Project Name: **Marlboro BRF 010-1(43)**
Structure Identification: **Bridge #48 on VT RTE 9 over Whetstone Brook**

The Temporary Bridge and detour plans received in this office on January 14, 2014 have been reviewed. Please address the comments below and resubmit the plans.

CROSS SECTIONS

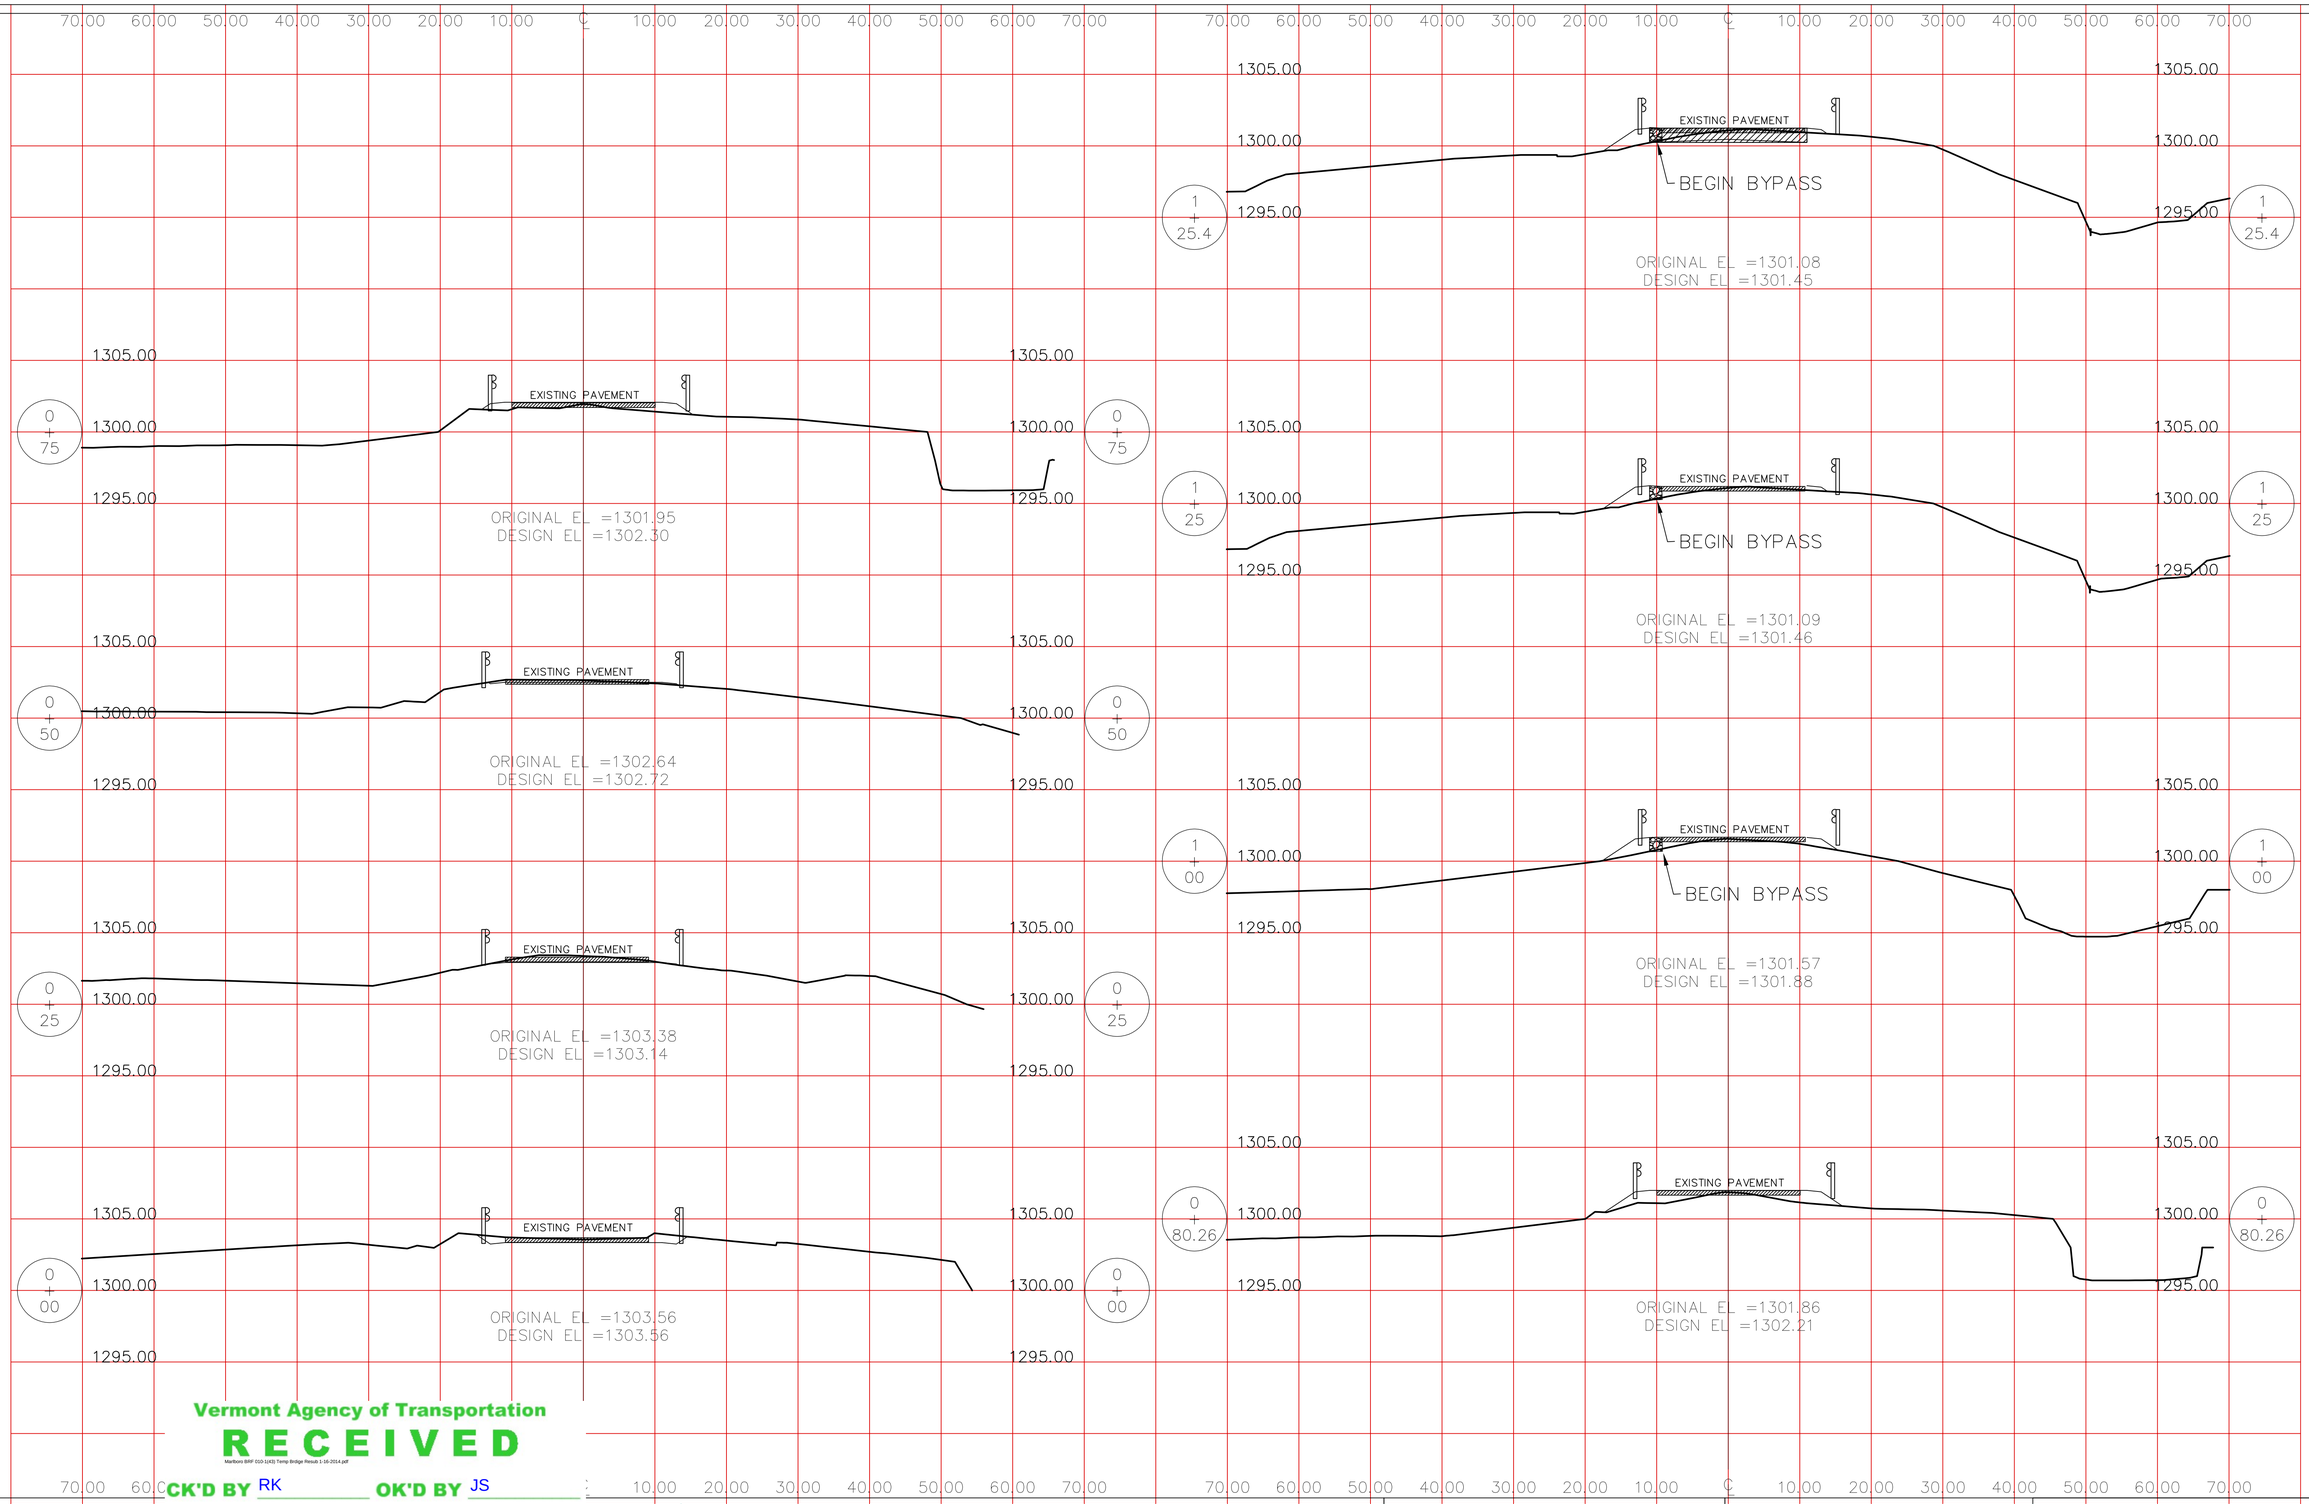
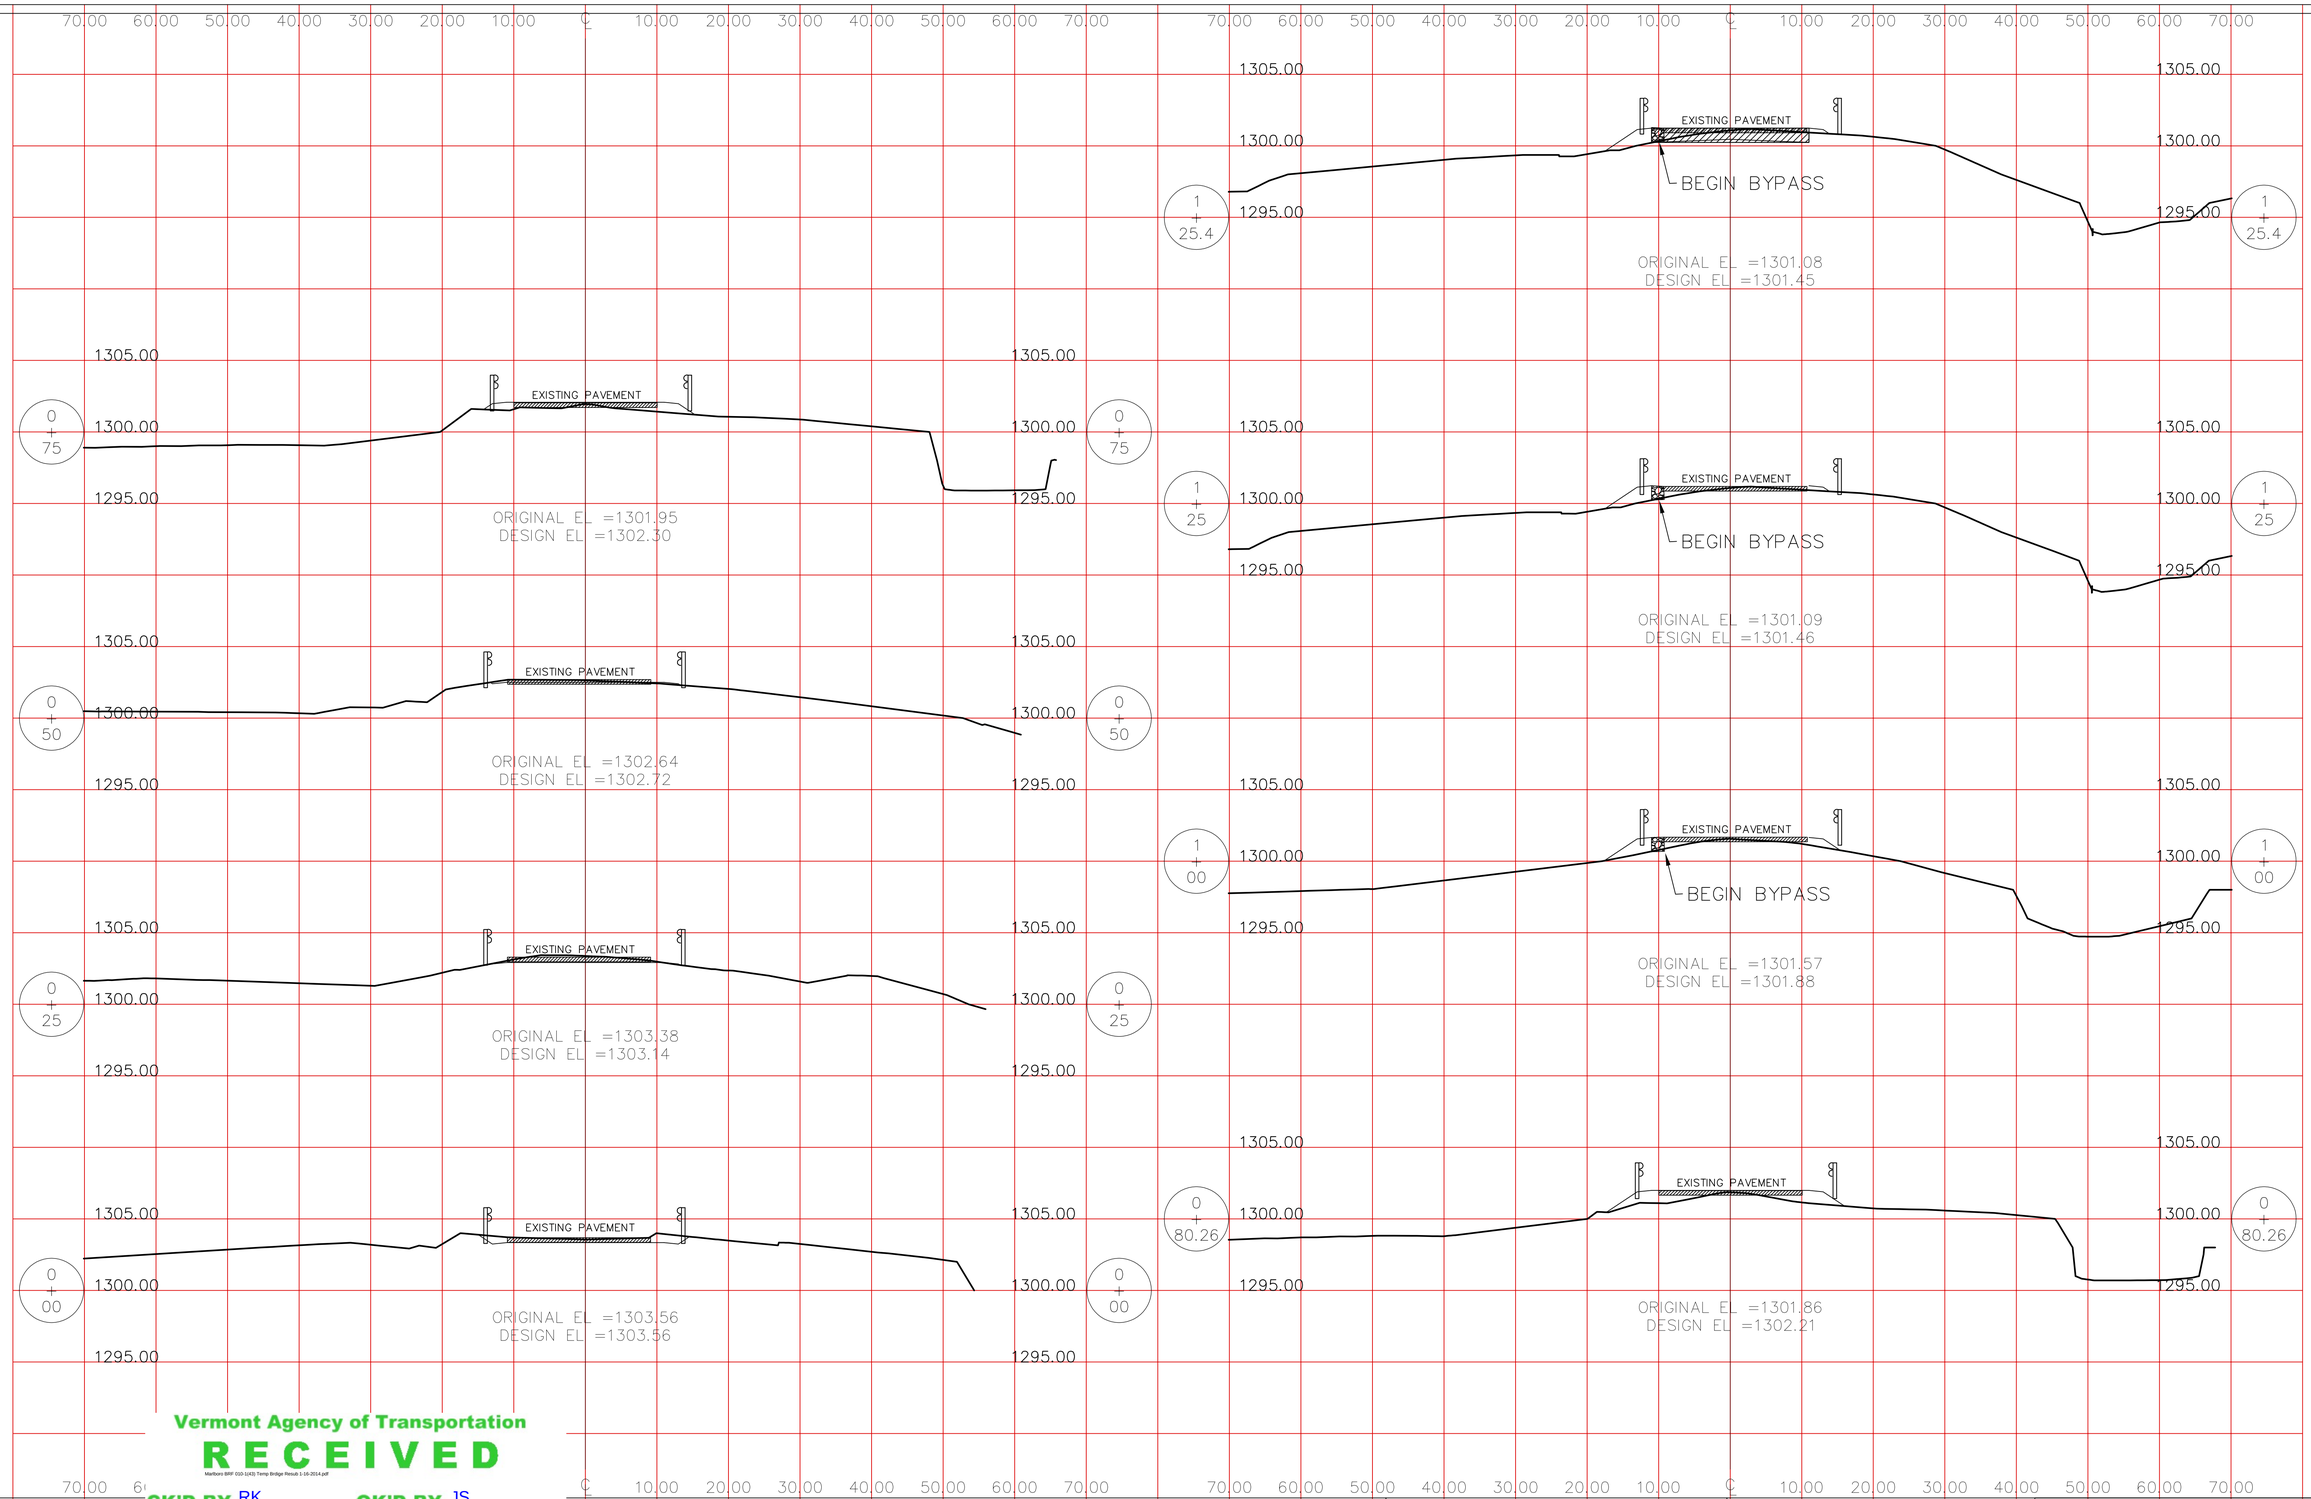
4. Cross Sections:
    a. Sections 1+50 through 2+50 are missing. Page 5 of 9 was duplicated in submittal, missing page 4 of 9?
    b. Show existing girder(s) that will be used for temporary bridge on sections.

c. Show portion of existing bridge deck that will be retained for temporary bridge on sections.
    d. Show roadway cross slope.
